INDESIT company

Model type:
MBA45D2NFI

Commercial code:
F038772

RE0224T0 Exploded views

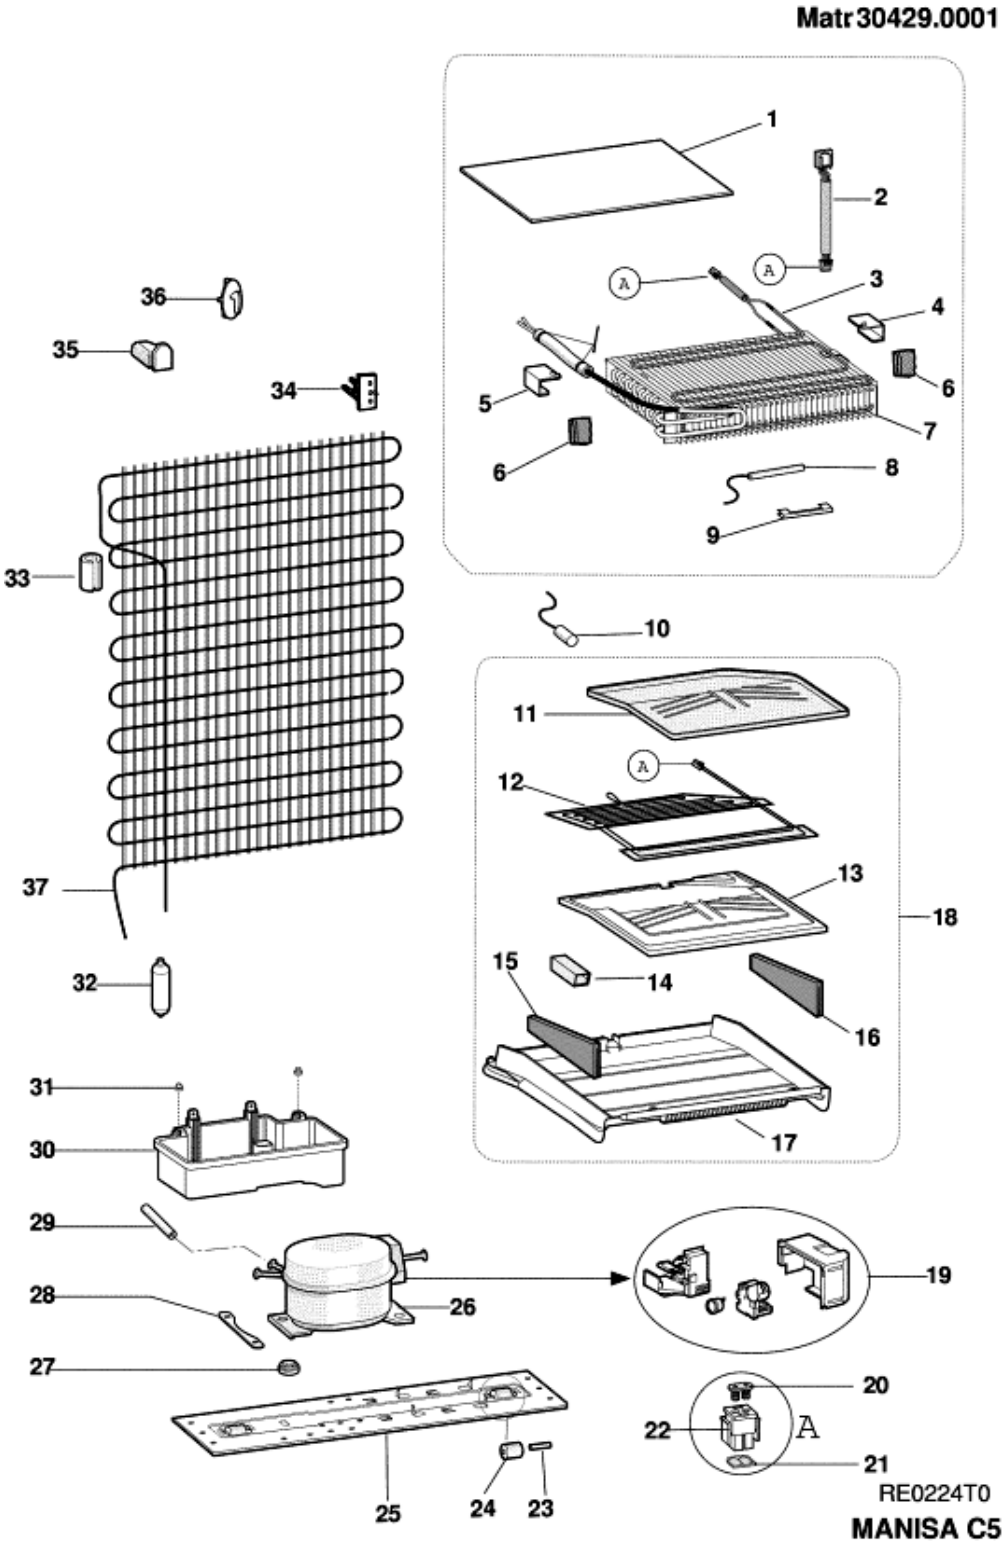
0999376: ICE FORMATION AT THE BACK OF THE EVAPORATOR

Below modifications have been performed to prevent ice formation at the back of the evaporator on L70 combies. These new parts can be supplied as an assembly C00141277
1- Spugnetta evaporatore left and right have been modified since 12/08/2005. Spare part codes remain the same (C00094468-C00094467). These parts must be replaced together in case of necessity of the replacement.

2- Power of the rezistance for divisorio camere has been increased from 40W to 50W since 03/10/2005. Spare part code remains the same (C00095774).

3- Power of the rezistance for evaporator has been increased from 140W to 150W since 26/09/2005. Spare part code remains the same (C00115199).

4- Drain hose end piece C00141278 has been used for draining the water to the evaporating tray since 26/09/2005.

These new parts can be supplied as an assembly C00141277.(TB001014 - ex.TECHNICAL NEWS STN-CL 0511.1)

RE0225T0 Exploded views

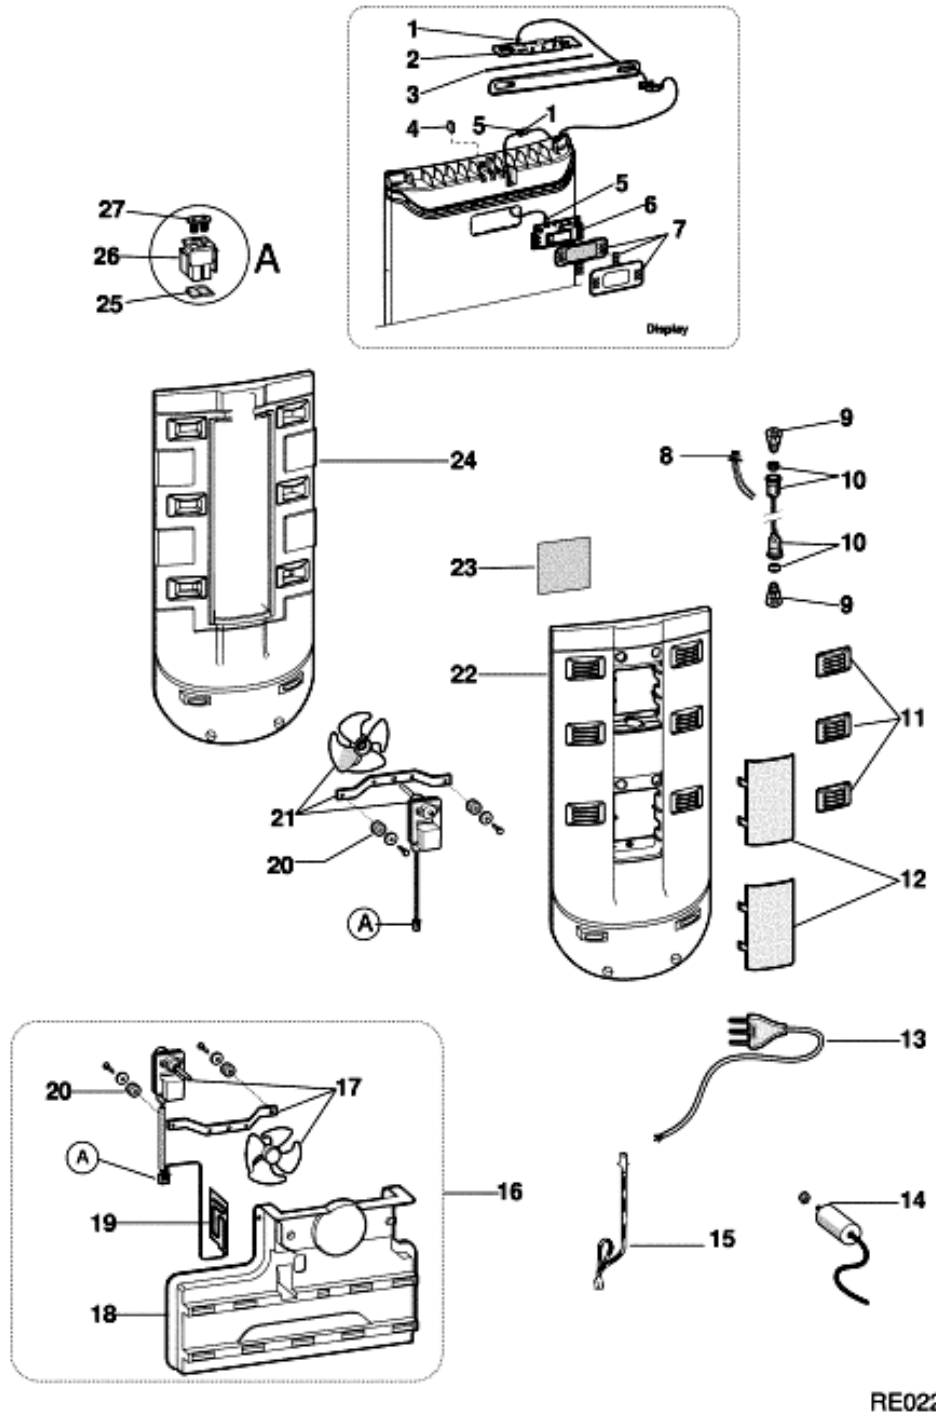
5- Fan motor plastic assembly has been modified. The hole for propeller has been modified to prevent friction between propeller and fan motor plastic since 03/10/05.
Spare part code remains the same (C00116498).

0999379: TWO HOLES HAVE BEEN CANCELLED ON MULTIFLOW FOR COMBIES

Due to low temperature at the lower part of the fridge section on Manisa combies two holes which are placed on multiflow cover have been cancelled for all combies since 13/04/2006.
